Our Ref: 501.00059.00017  
Your Ref: W0272-01

**RE: ROADSTONE WOOD LIMITED : WASTE LICENCE APPLICATION  
MILVERTON WASTE RECOVERY FACILITY  
RESPONSE TO ARTICLE 14 COMPLIANCE NOTICE**

ROADSTONE DUBLIN LTD.  
 WASTE LICENCE APPLICATION  
 WASTE RECOVERY FACILITY,  
 MILVERTON, SKERRIES, CO. DUBLIN  
 SITE INFRASTRUCTURE LAYOUT

**FIGURE E1.1 REVA**

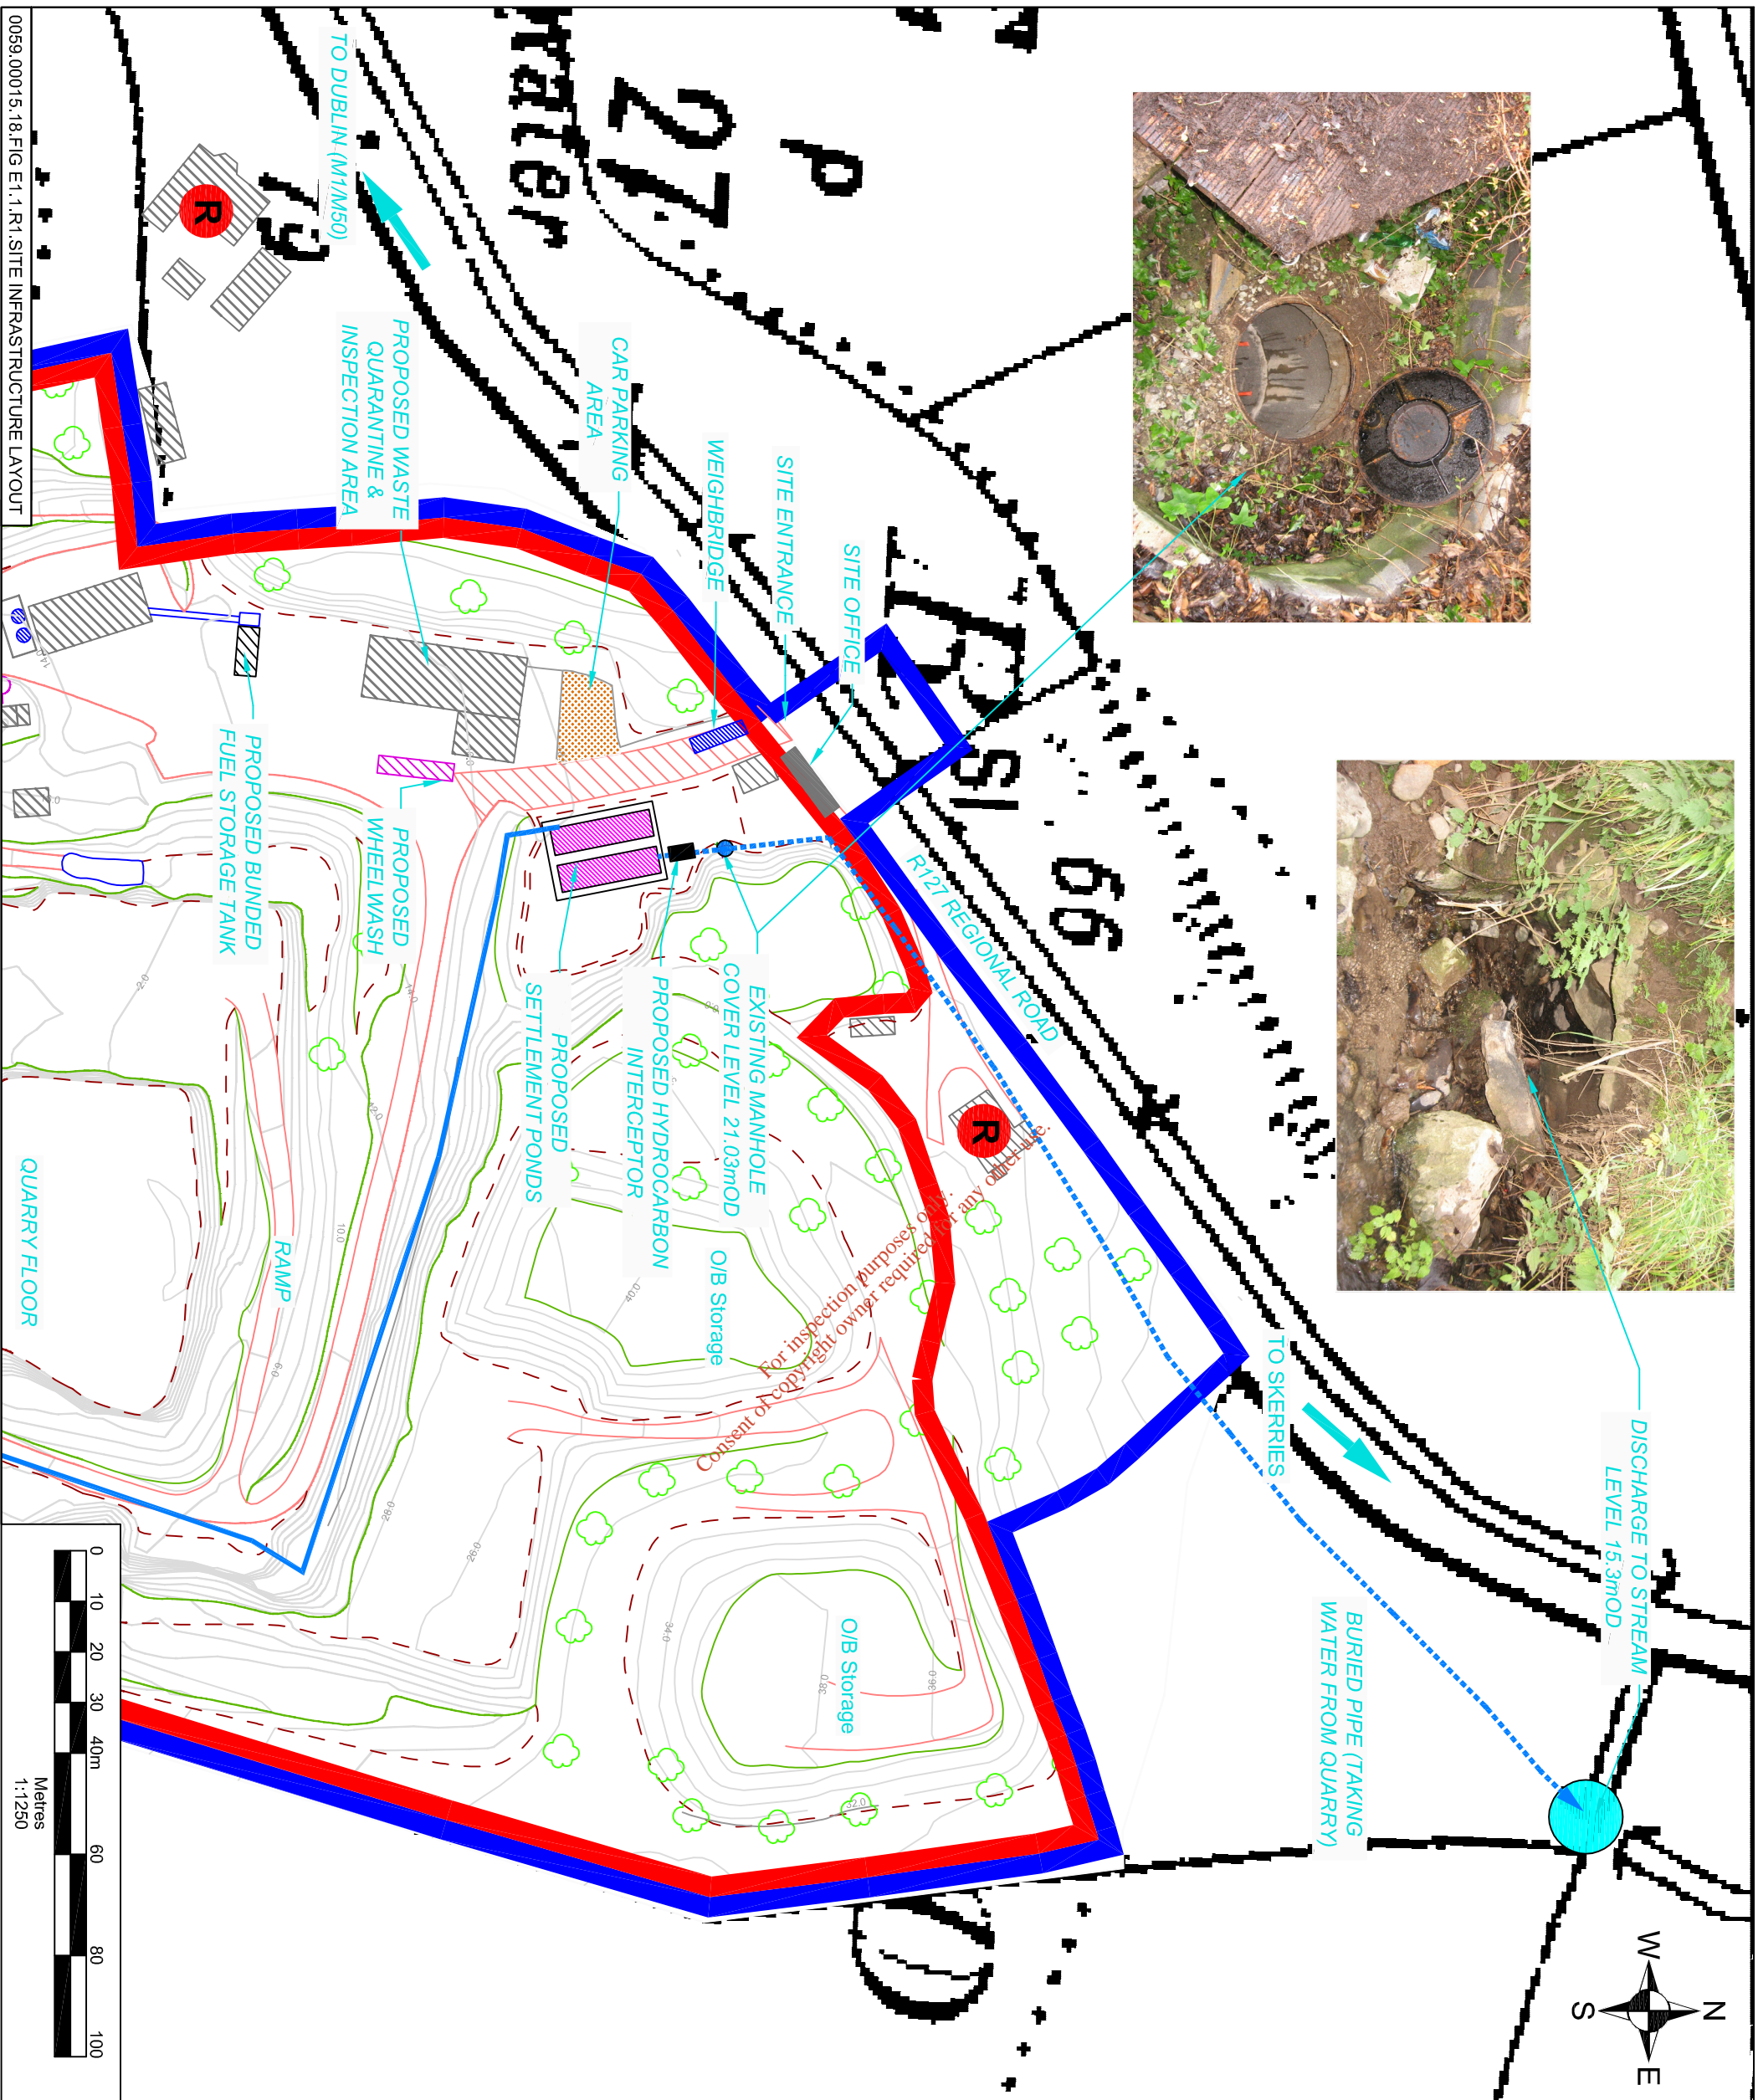
- (iv) Confirm the route of the existing pipeline from the quarry to the receiving water. Alternatively identify an alternative proposed route for discharge of the on-site water to the receiving water. Clarify the location of the existing or proposed discharge point to the receiving water and provide the grid reference. Identify the existing or proposed discharge route on a fully labelled drawing.**

- (iv) As was previously alluded to, it is envisaged that the existing surface water discharge pipe between the quarry and the tributary of the Mill Stream will continue in service during the quarry backfilling and restoration phase.

A follow up topographical survey was undertaken at the application site on 26 November 2010. The principal objective of this survey was to locate the start and end points of the existing discharge pipe and the crown and invert level of the pipe at either end. The start point for the 150mm diameter discharge pipe is located at the base of a manhole in the former retail centre (at Grid Reference 324648E and 259158N), located at the front (northern end) of the quarry. The invert level of the pipe at this point lies approximately 4.5m below the ground surface, at 16.56mOD.

The end point for the discharge pipe daylights as a stone culvert in the bank of the tributary to the Mill Stream, beyond the north-eastern boundary of the quarry and close to a right angle bend in the channel (at Grid Reference 324838E and 259329N). It is known that quarrying activity has been undertaken at the application site since the mid-1800's and the presence of the stone culvert would suggest that this discharge has been in use for a considerable period of time. The invert level at the discharge point is 15.36mOD, 1.2m lower than the invert level of the pipe at the quarry, giving an average pipe gradient of approximately 1 in 200 (0.0005). Drawing E1.1 has been updated to show the surveyed start and end points of the discharge pipe and its inferred alignment.
